The Cutaway — Architectural Design Response
iNSW — Rev G — 31/08/23

Project Name	The Cutaway		
Project Code	BCY		
Revision	Date	Comment	Approved
0	31/05/23	Draft Issue	EC
A	06/06/23	Issue for Review	EC
B	07/06/23	Final Issue	EC
C	14/06/23	Final Issue	EC
D	26/06/23	Final Issue	EC
E	21/07/23	Reissue for DPE	EC
F	27/07/23	Reissue for DPE	EC
G	31/08/23	Reissue for DPE	EC
H	08/09/23	Reissue for DPE	EC

Entry Forecourt

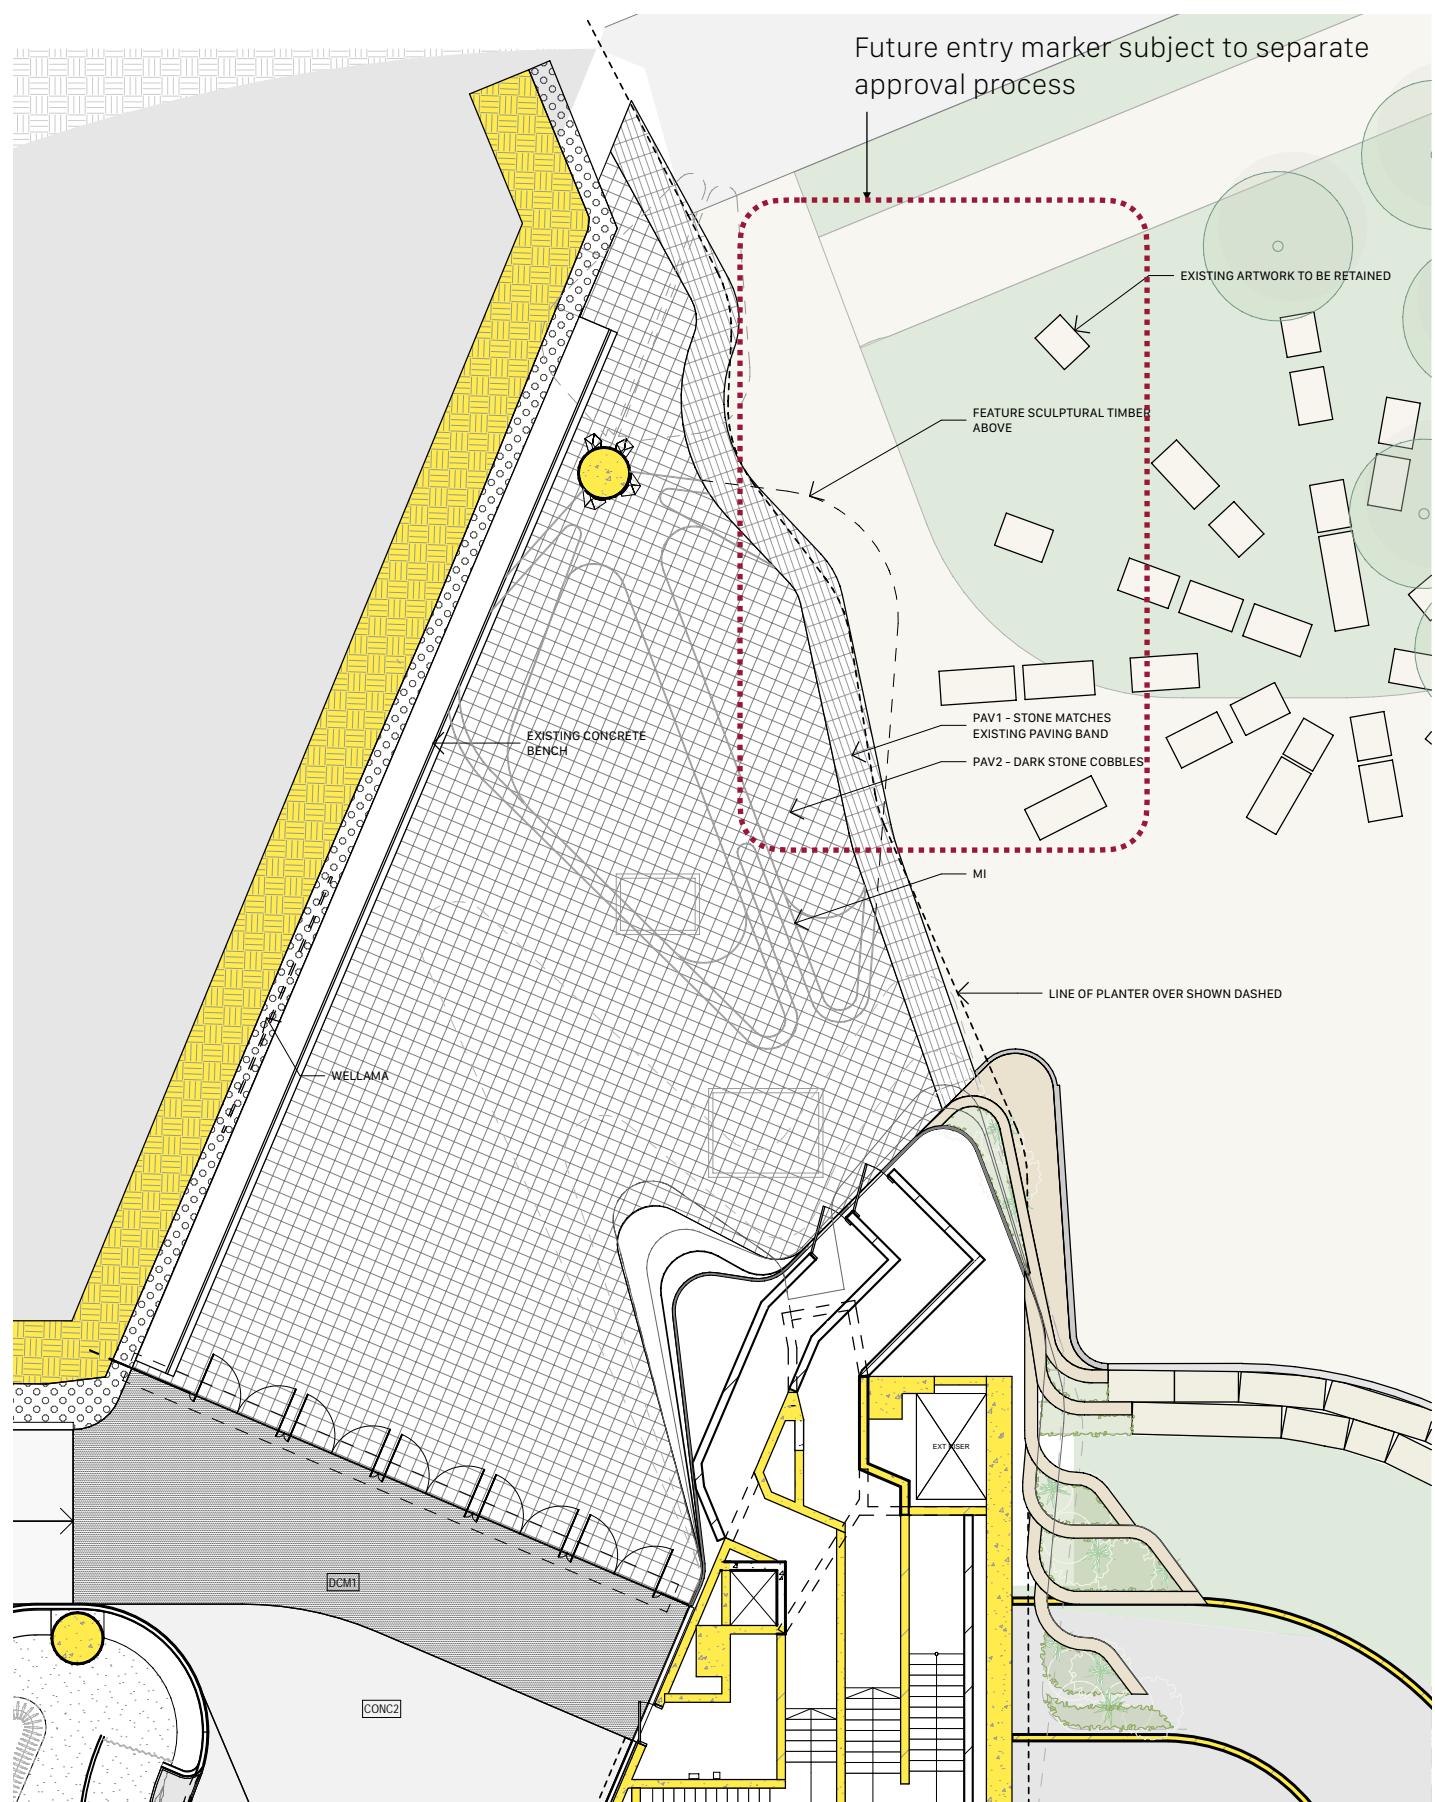
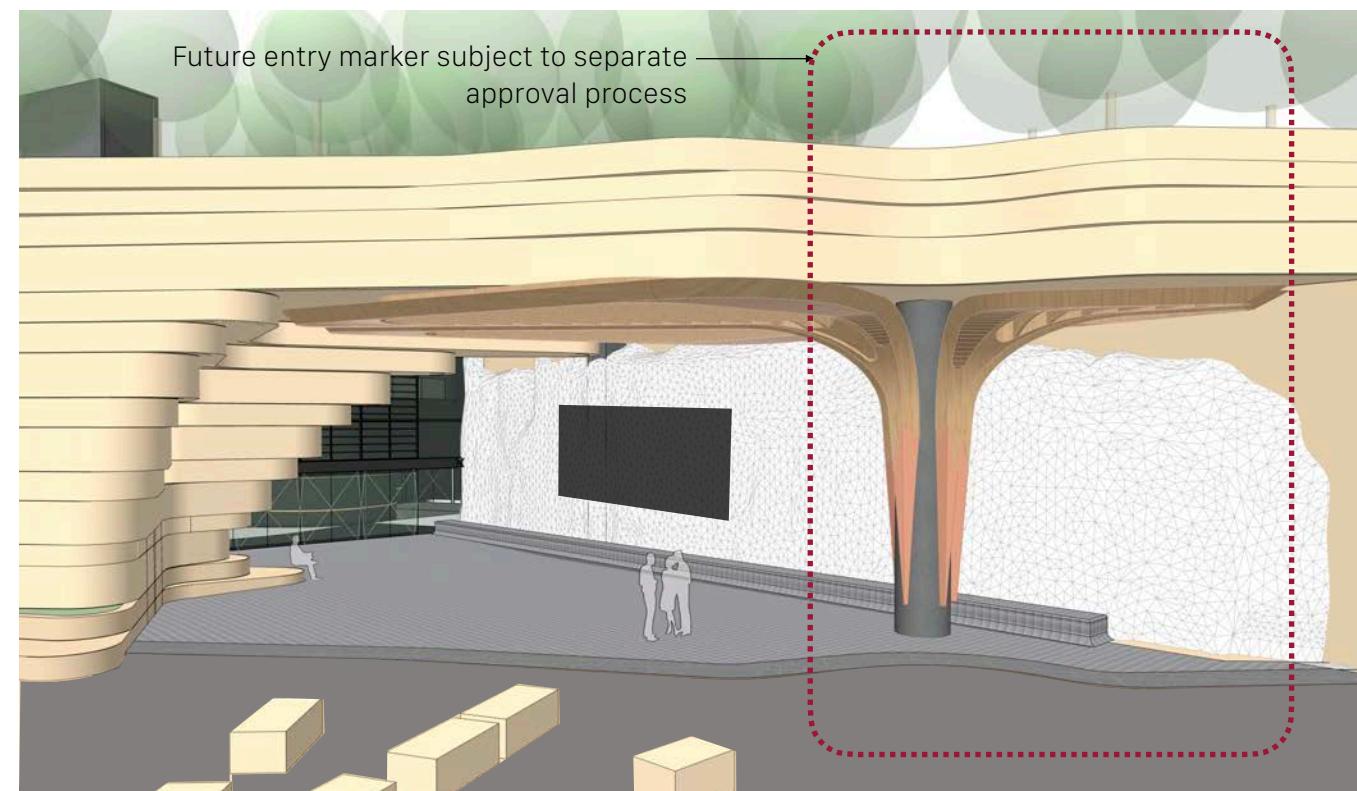
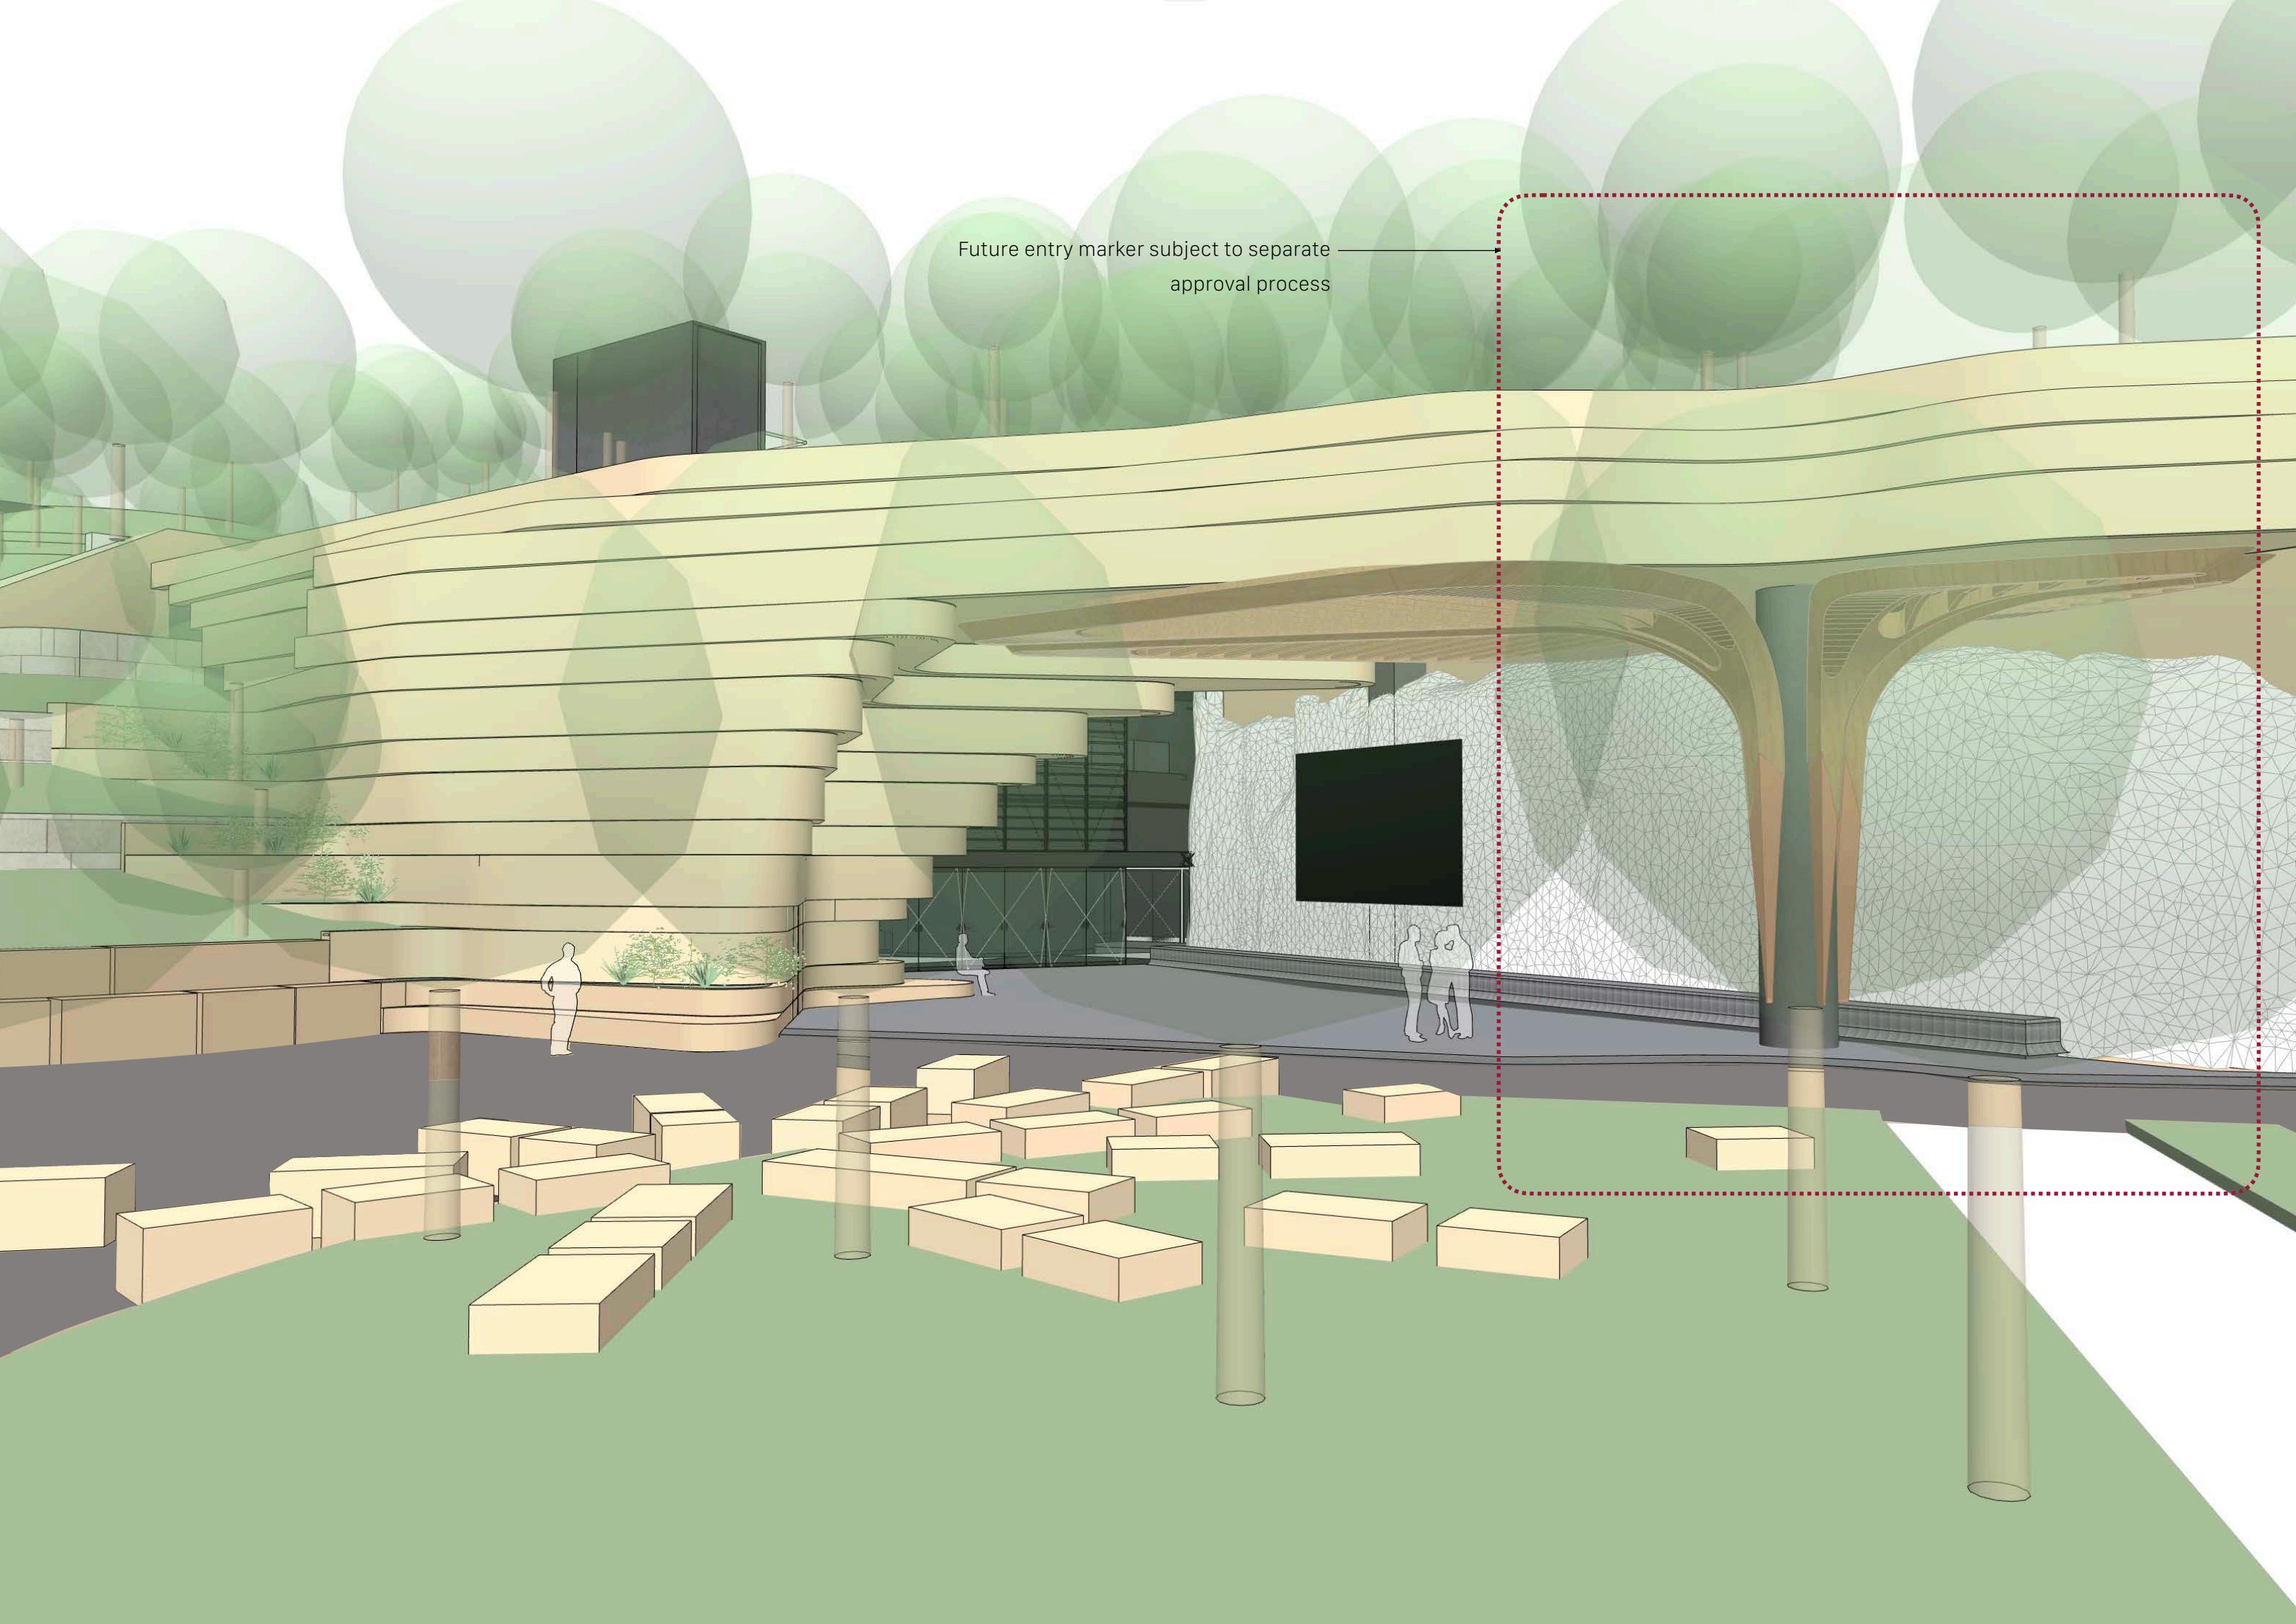
Clarify the purpose of the entrance forecourt – it has been described as a hearth, ceremonial space, entrance to a cave and a gathering space, all of which have varying spatial considerations

The intention of the fjcstudio, Jake Nash and Bangawarra Team is that the experience upon crossing the threshold into the Cutaway is inclusive and welcoming. The concept of the 'hearth' is a welcoming symbolic gesture, which provides an informal threshold and gathering space. This space is not programmed, however it can be used for a diverse range of events and cultural practices.

The experience, developed in collaboration with Jake Nash and Bangawarra, will celebrate the existing sandstone entry wall and the concept of 'welcome' and 'healing'. The area of the existing forecourt remains unchanged, however, the articulation around the edges has been reconfigured to provide a more welcoming and inclusive entrance into the Cutaway and to provide a stronger, more compelling connection with the interior space. The undulating cladding elements enhance the natural, cave-like qualities of the space. Although not a space to be officially programmed, it will act as an informal threshold and gathering space. The following elements will enhance the experience of the threshold:

- a curved sandstone seat is incorporated into the base of the western masonry landscaped feature which provides a natural sitting edge using the natural sandstone.
- the new paving will gently curve up to meet the existing sandstone wall to the east, providing a softer and more welcoming response to the base of the wall and concealing the existing rectilinear concrete beam.
- a subtle etching/insertion of brass within the paving provides a shadow of the profile of the "sculptural timber" canopy above (coded MI on the plan)
- engraved words and symbols of meaning will be incorporated into the timber base of the "sculptural timber elements"
- the "sculptural timber elements" will provide an indication of shelter and filtered light indicating refuge and welcome.

Skylights

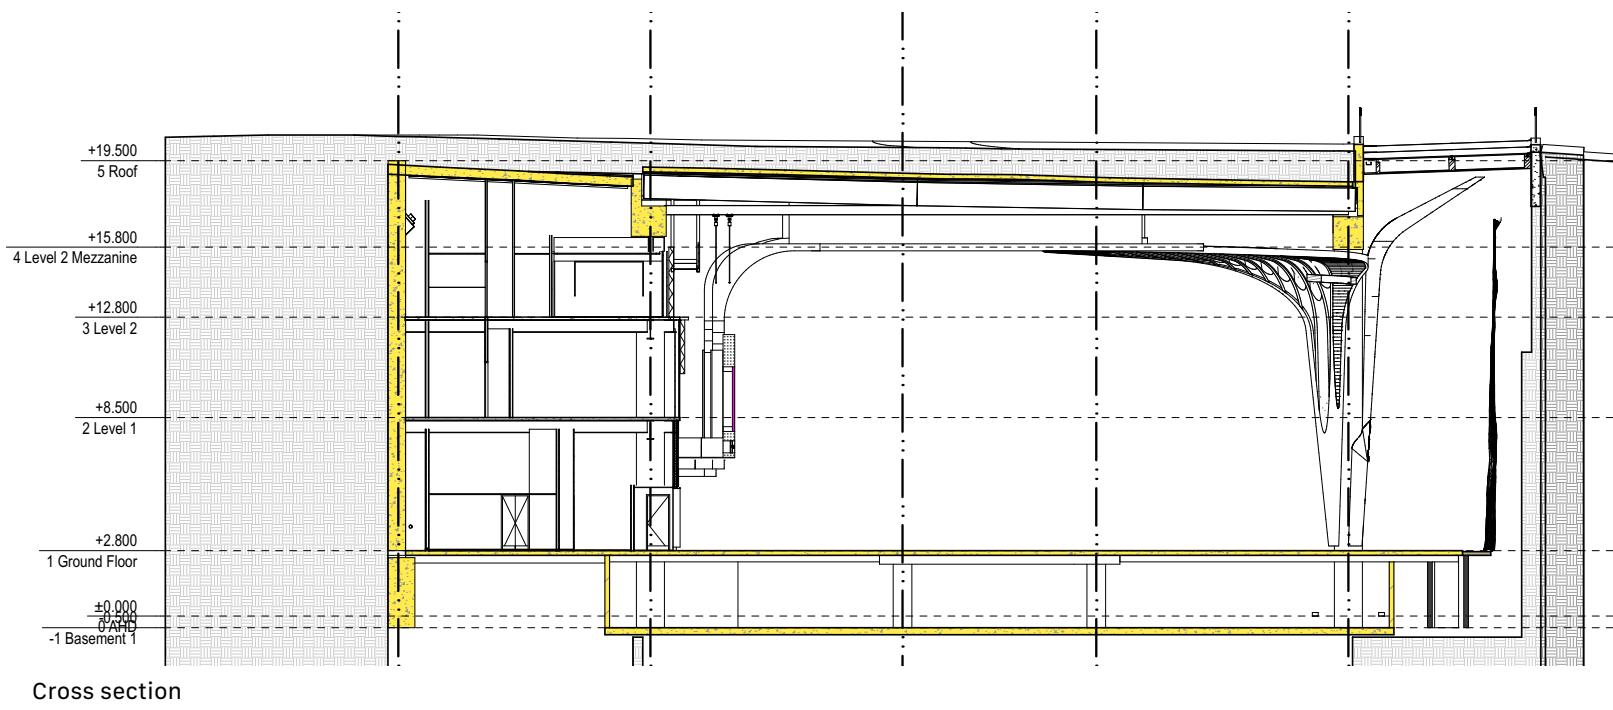
Proposal to permanently seal off existing skylights will break the sense of connection to the outside and alter the experience for users of the space. The venue needs to be able to both 'breathe' and be fit-for purpose for events as needed

The infill skylights' top surface is to be set no higher than the asphalt surface of Merriman Street to minimise the skylights visual impact on the streetscape and heritage terraces

Retention or reinstatement of existing palisade fences at edges of the infill skylights is not shown in the architectural drawings

Skylights – The proposed skylight design includes a maintenance hatch and smoke exhaust plenum design to the western edge, that may potentially vent to the trees and landscaping. The exact zone of works, fences, and the skylight and mechanical design impacts on the park and existing trees in Barangaroo Reserve is not clear. There is no tree survey, concise scope of works plan and the submitted report states that "all trees will be protected and replaced if affected by works to the skylights". Any tree removal is not supported.

As recommended by GML Interpretation Plan, the existing concrete sign on Merriman Street should be retained and integrated with a permanent interpretive device for the purpose of interpreting the HCT.

Consider the location of service risers and their impact on the overall spatial layout, skylights, and public domain above.

It is noted that many services are located under the skylights, therefore matters such as waterproofing, visual impact, ventilation, and maintenance must be resolved.

In order to meet both the project brief and the noise requirements, the Cutaway venue is to be sealed and the skylights will provide a waterproof enclosure.

To meet the brief requirements for a multipurpose facility, it is important that the environment can be controlled due to not only the acoustic requirements but also to maintain the investment of the highly technical equipment required to service the multipurpose function. The existing sandstone wall will be left untouched and will be allowed to "breathe". We note the current gravel drain to the base will be maintained to enable the sandstone to naturally exfoliate and seep moisture, whilst draining away any excess at the bottom.

To provide a high level of amenity a mixed mode system is used, and, in many instances, natural ventilation can be activated. Whilst in air-conditioned mode, a 100% fresh air system is used with CO₂ monitors. The sky can be viewed through the skylights when desired.

The skylight works are concentrated in the existing roof voids only, and do not require the removal of any existing trees. The very localised works occurring around the northernmost skylight, do not require any trees to be removed. The existing Harbour Control Tower concrete sign around this area on Merriman Street will be retained as part of the works, and the existing palisade fence will be removed and reinstated.

There are no service risers as part of the skylight design that will extend beyond the asphalt of Merriman Street — any services below the skylight internally have been integrated with the architecture. Please refer to the sections on the following page for the developed skylight design.
